APPROVED
CITY OF LAKE WORTH
Date 10-30-67
L Welch
Building Inspector
Phone JU 5-2571, Ext. 35
Before pouring any Concrete.

ADDITIONS TO CUYLER PAVILION
LAKE WORTH . FLORIDA
FOUNDATION & PLOT PLAN

ISS. 10-12-67	FOR APPROVAL		COMM. NO. 67-75
			SHEET NO. 1 OF 9
REV.

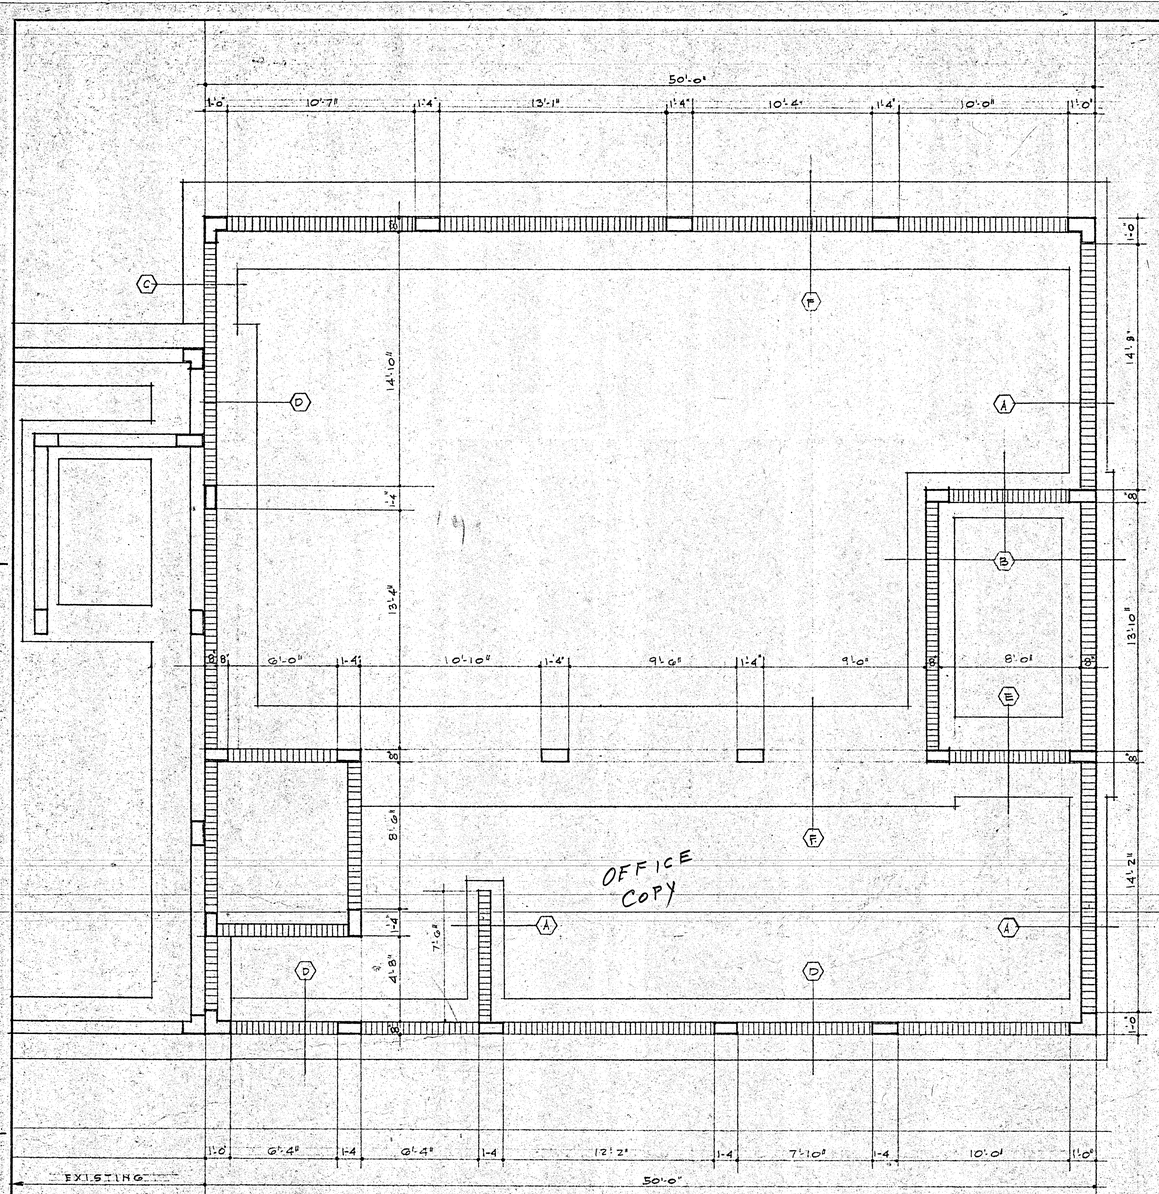
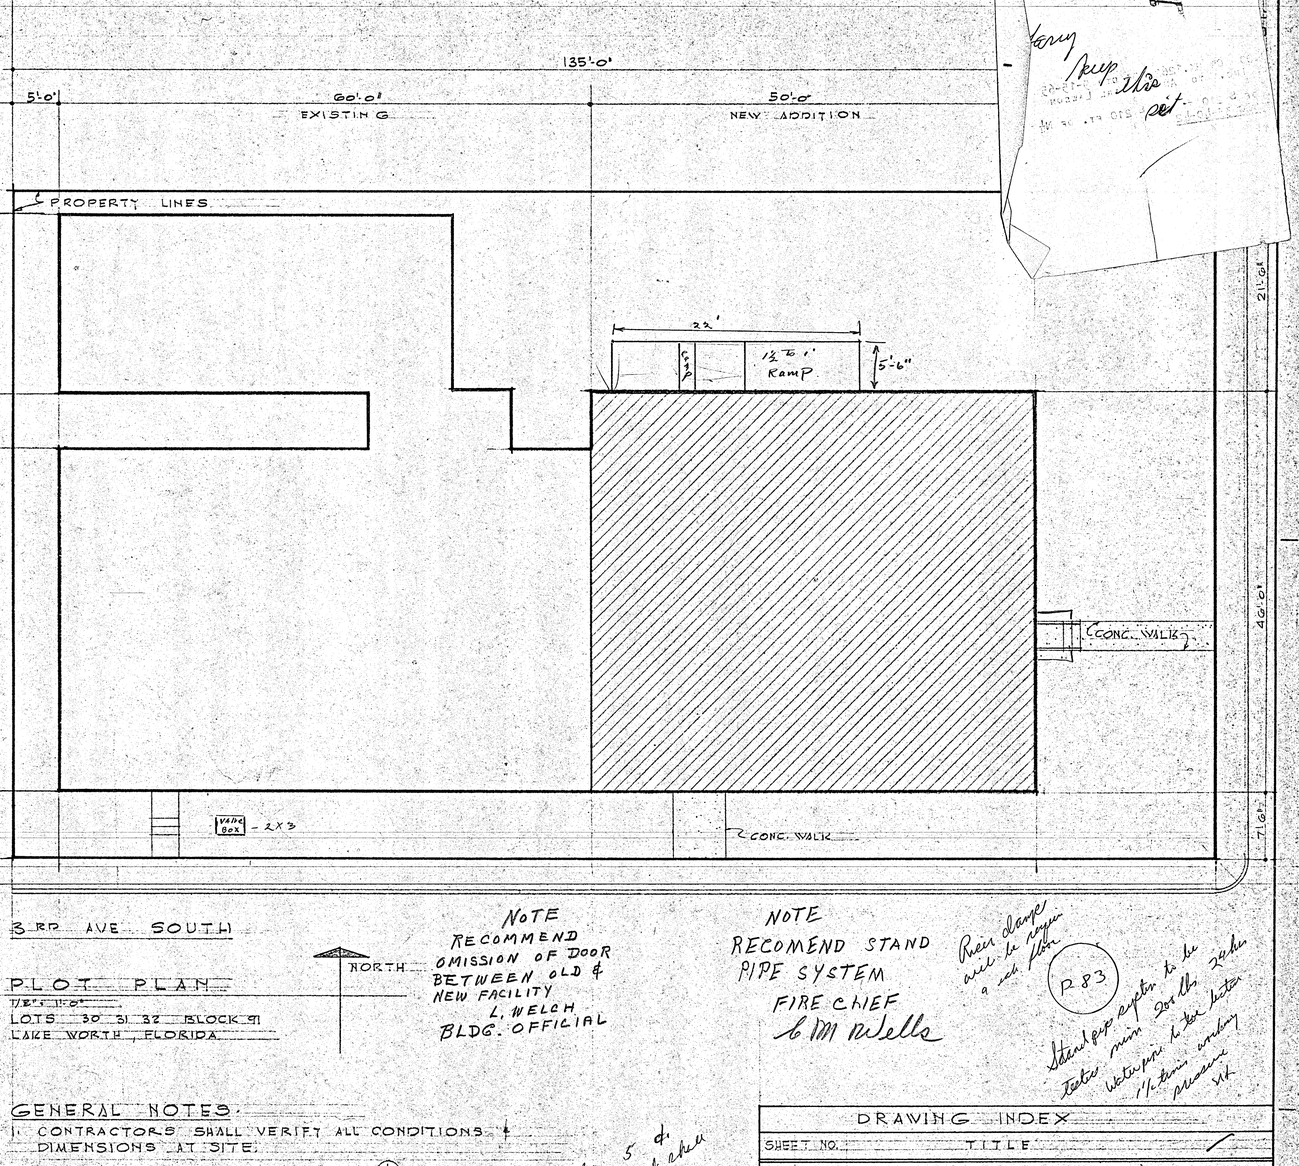
NOTE
RECOMMEND
OMISSION OF DOOR
BETWEEN OLD &
NEW FACILITY
L. WELCH
BLDG. OFFICIAL

NOTE
RECOMEND STAND
PIPE SYSTEM
FIRE CHIEF
G M Wells

Rear ramp will be proper 9 inch slope

Stand pipe system to be tested min 200 lbs 2 hrs water pipe to be tested 1½ times working pressure

Section 5 & 2W plumbing code shall apply

ADDITIONS TO CUYLER PAVILION
LAKE WORTH · FLORIDA
PLUMBING PLANS & DIAGRAMS

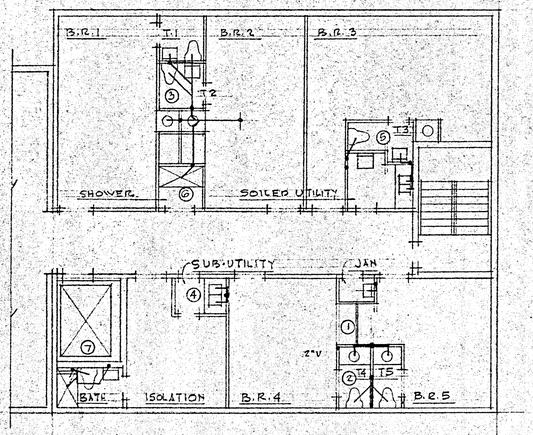
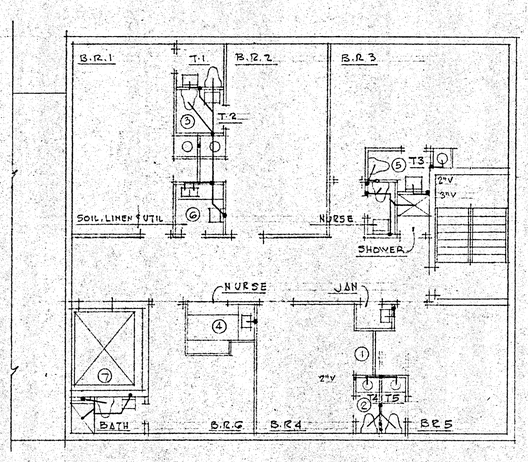
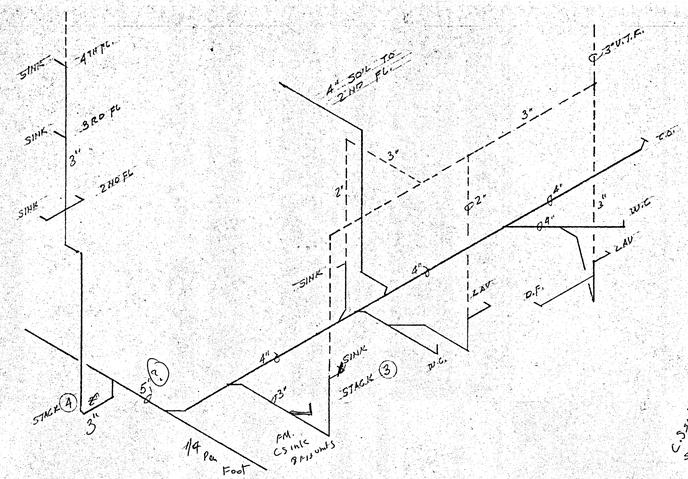
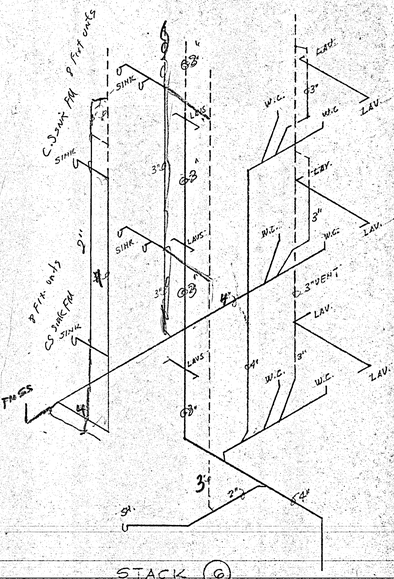
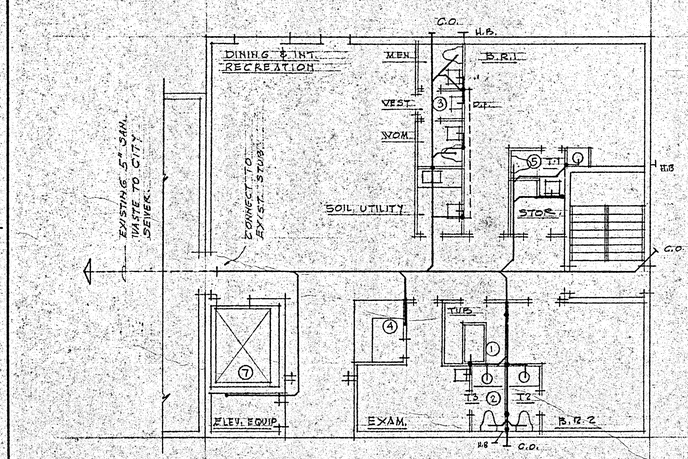
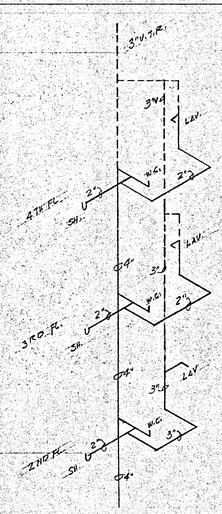
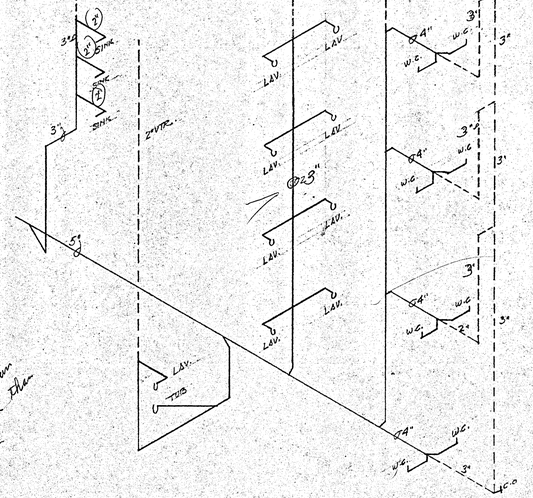
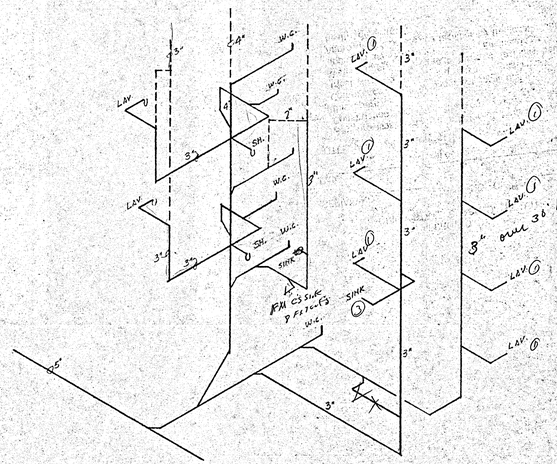
Section 5 d. 1.2 Plumbing Code also apply

1/4" per foot slope to maintain 1 5" diam. velocity

Plumbing fixt. shall furnish size diagram if installed other than shown on plan
